UNITED STATES PATENT AND TRADEMARK OFFICE

| APPLICATION NO. | FILING DATE | FIRST NAMED INVENTOR | ATTORNEY DOCKET NO. | CONFIRMATION NO. |
|---|-------------|----------------------|---------------------|------------------|
| 10/642,689 | 08/19/2003 | Yong-Sok Yang | 1349.1278 | 2721 |

| Office Action Summary | Application No. | Applicant(s) | |

DETAILED ACTION

Fig. 8***Allowable Subject Matter***

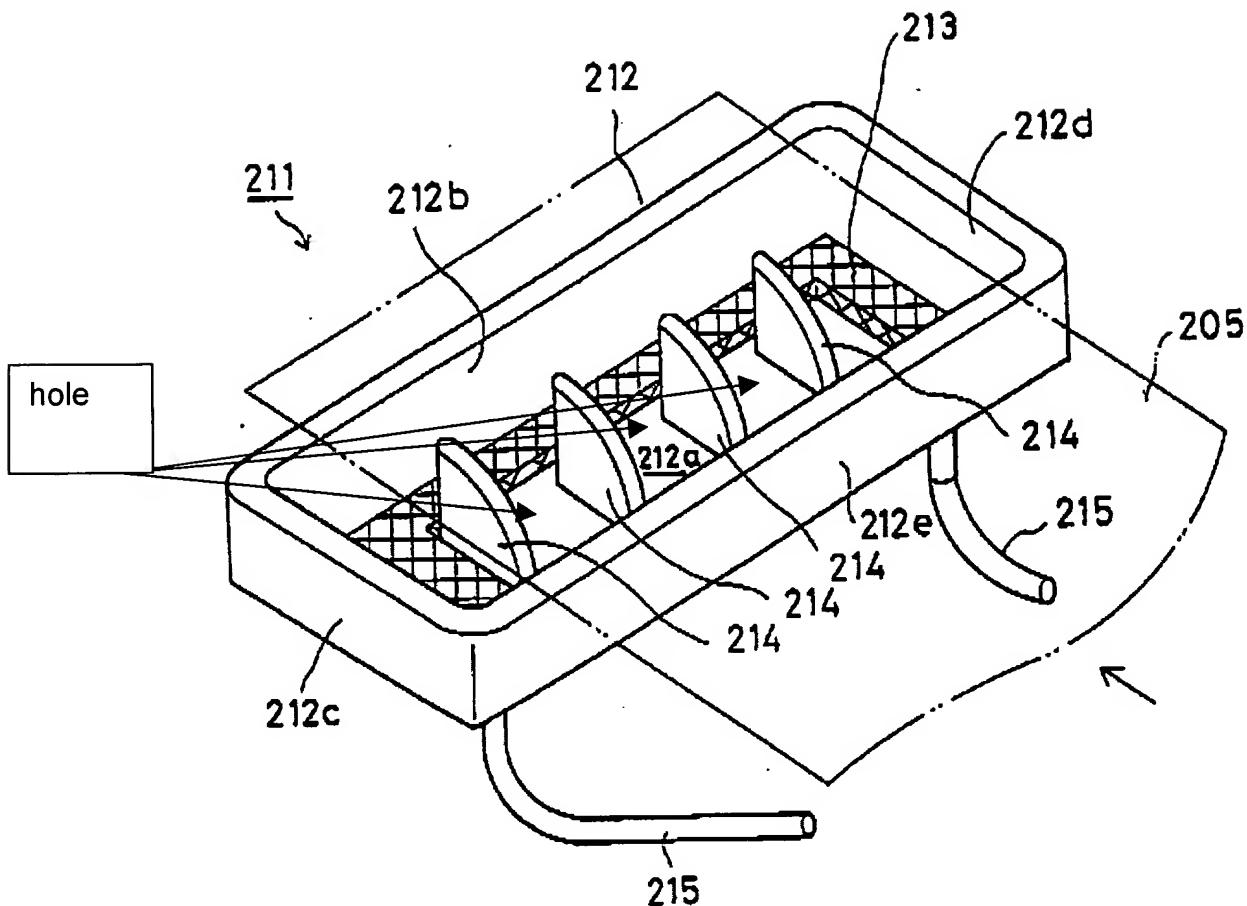
2. Claims 10-12, 21 and 22 are rejected under 35 U.S.C. 102(b) as being anticipate by Matsuhashi (EP 707973).

With respect to claims 10-12, 21 and 22, Matsuhashi discloses an apparatus comprising:

- A print head (Fig.7: element 203) to eject ink toward a paper (element 205);

- A frame (Fig.7: element 212) to guide the paper, the frame forming a hole (Fig.8) to pass the ejected ink not received by the paper (abstract);
- Paper maintains a constant had gap with the frame (by having the frame 3, a constant gap is provided between the head and the paper);
- A waste collector (Fig.8: element 213) to collect the ink which has passed through the hole.
- The ink passes through the hole when the paper partially cover the hole (Fig.7, 8, Abstract, with borderless printing, the ink must passes through the hole when the paper partially cover the hole)
- The ink not received by the paper is not receive during a printing operation (fig.7, 8, abstract)
